Independent Hearing and Assessment Panel

Tuesday, 22 August 2017

IHAP002-18 Demolition of existing structures, construction of a multi dwelling housing development containing 4 dwellings including basement car parking and two swimming pools - Actinotus Avenue, Caringbah South (DA17/0135)

FILE NUMBER: DA17/0135

A section of the ground floor plan showing the rear basement stair case setback 900mm from the eastern side boundary of the site.

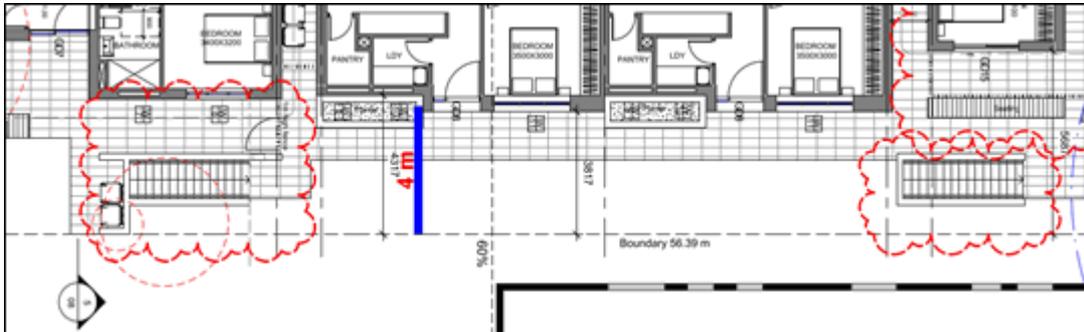
The stair case leading up from the basement toward the rear of the site is proposed with a reduced setback of 900mm from the eastern side boundary for a length of 3.9m. See plan below:

New screen planting along the side boundary and the boundary fence will obscure the stair structure from the adjoining property. The basement stair landing will be no more than 300mm above the existing ground level and therefore the location and use of the structure will unlikely result in significant amenity impacts on the adjoining property. Particularly given that it is unlikely to be heavily trafficked, as each unit has internal access from each garage.

A section of the ground floor showing the entrance to Dwelling 3, setback 3.81m from the eastern side boundary.

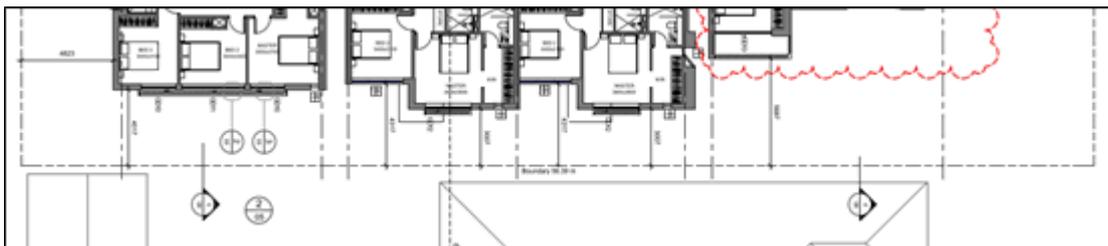
The front door/entrance to Dwelling 3 is proposed setback 3.81m from the eastern side boundary. See plan below:

A wide dense landscape strip including screen planting, shrubs and grasses will be provided adjacent to the eastern boundary creating a buffer between the adjoining property and entrance. This landscaping (once established) and boundary fence will obscure the entrance from the eastern adjoining property, mitigating potential visual and acoustic impacts.

A section of the second storey level showing the north eastern corner of Dwelling 3, setback 3m from the eastern side boundary.

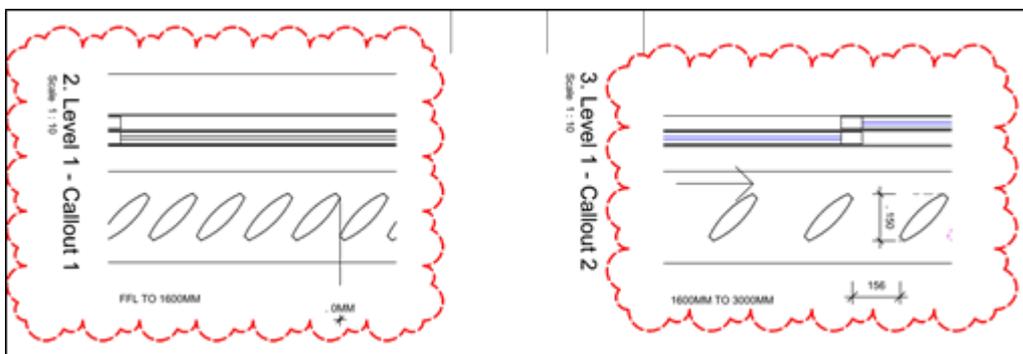
The south eastern wall of the master bedroom of Dwelling 3 is setback 3m from the eastern side boundary, for a length of 2.2m and includes part of the 3m high window for a length of 1.4m. See plan below:

To minimise overlooking impacts on the private open space of adjoining properties, external privacy screens comprising vertical louvres are proposed. In addition, shadow diagrams provided demonstrate that the minor encroachment will have no significant shadowing impacts on the eastern adjoining property. The articulation and varied materials used with the design, breaks up the length of this elevation and softens the bulk and scale of the development.

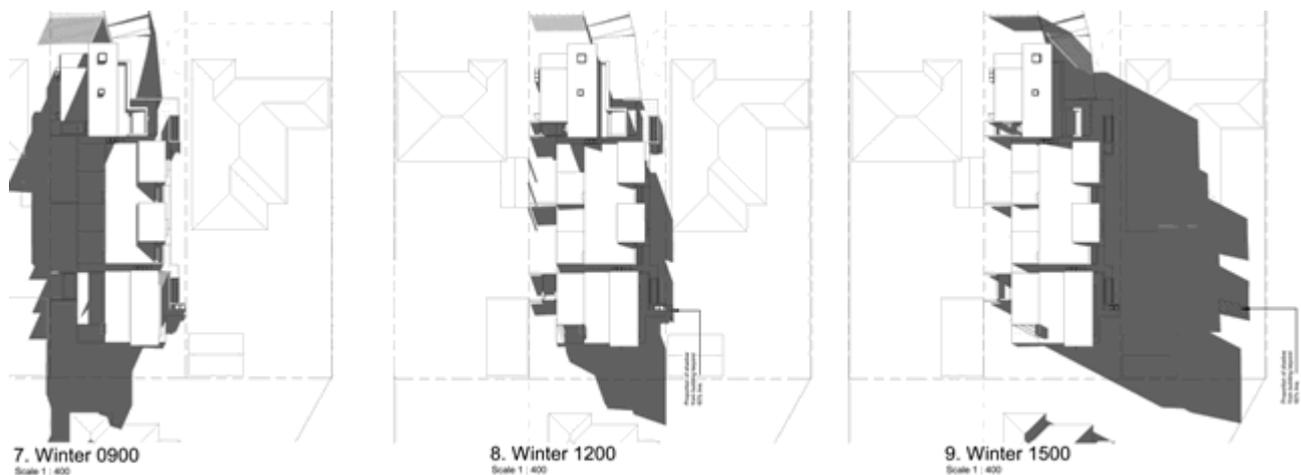
The screen detail provided shows the screens up to 1600mm above the finished first floor level angled to prevent occupants from looking straight out and down. The screening above 1600mm is on the same angle with larger spacing provided between each louvre. Based on this information, to prevent any overlooking from the first floor windows and balcony, it is recommended that the screen detail provided below in Callout 1 continue up to 1700mm above the first floor level on the windows and balcony. See screen detail below:

- i) The screen detail shown in 'Callout 1' for the windows and balcony on the eastern elevation must continue up to 1700mm above the finished first floor and must be fixed at all times.
